Fig. ~~fig.~~ 4B

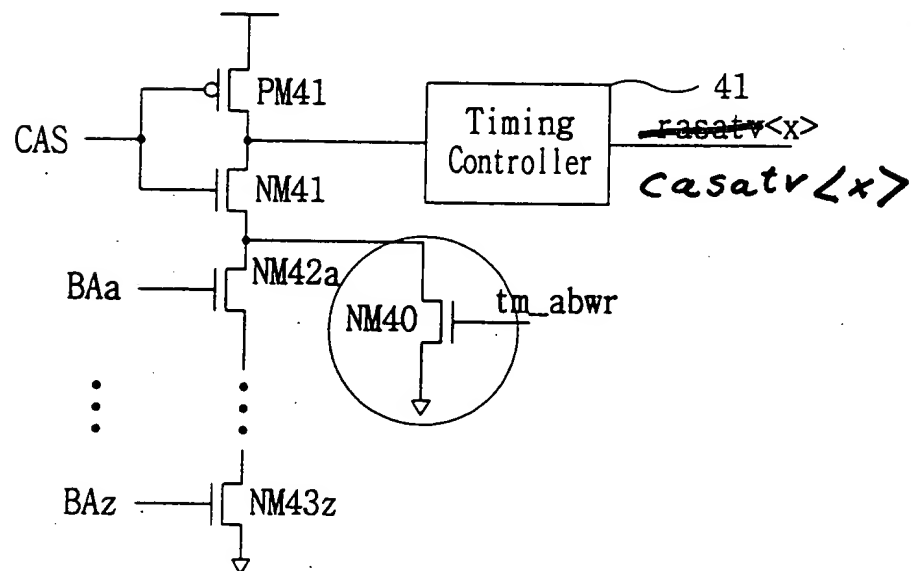
The drawings are objected to because in figure 4B, the signal "rasatv<x>" should read --casatv<x>-- and in figure 5, the reference "60" as described in the specification is missing.

Subject to the Examiner's approval, a Letter to the Draftsperson is herewith submitted proposing corrections to the drawings of Figs. 4B and 5 which obviate the Examiner's objections. Additionally, and subject to the Examiner's approval, a further correction to the drawing of Fig. 6 is likewise herewith proposed.

The proposed correction to the drawing of Fig. 4B corrects "rasatv<x>" to --casatv<x>-- to obviate the Examiner's objection. Support for the proposed correction is found at page 7, line 18, of the specification.

Fig. 6

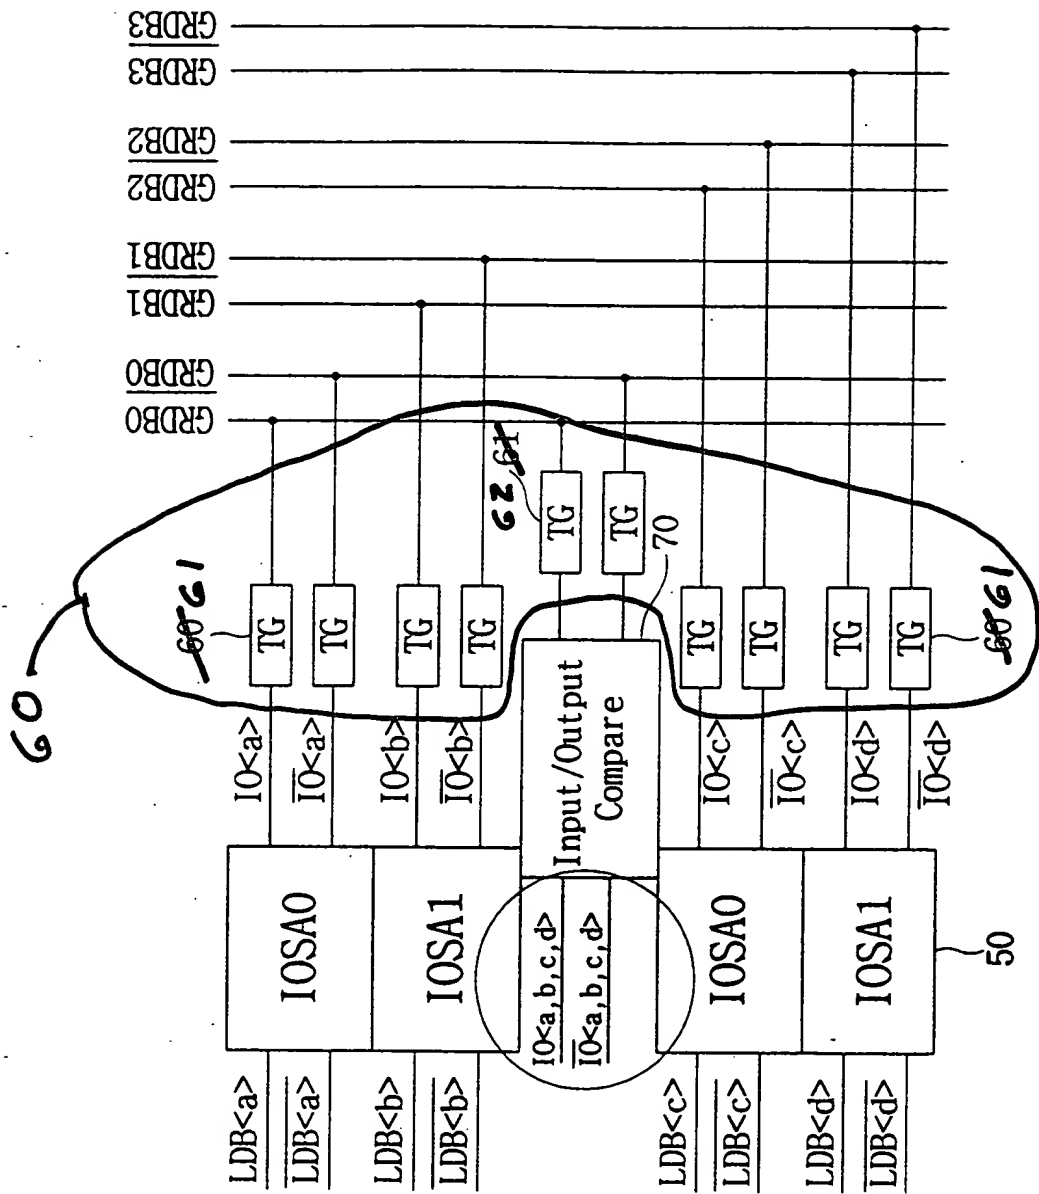
The proposed corrections to the drawing of Fig. 6 are to correct typographical errors relating to the first and second transmission gates and to identify those aspects of Fig. 6 which

comprise element 60. Support for adding reference numeral --60-- is found at page 7, lines 29-31, of the specification. Support for changing existing reference numeral "60" to --61-- is found at page 7, line 31, through page 8, line 1, of the specification. Support for changing existing reference numeral "61" to --62-- is found at page 8, lines 6-8, of the specification.
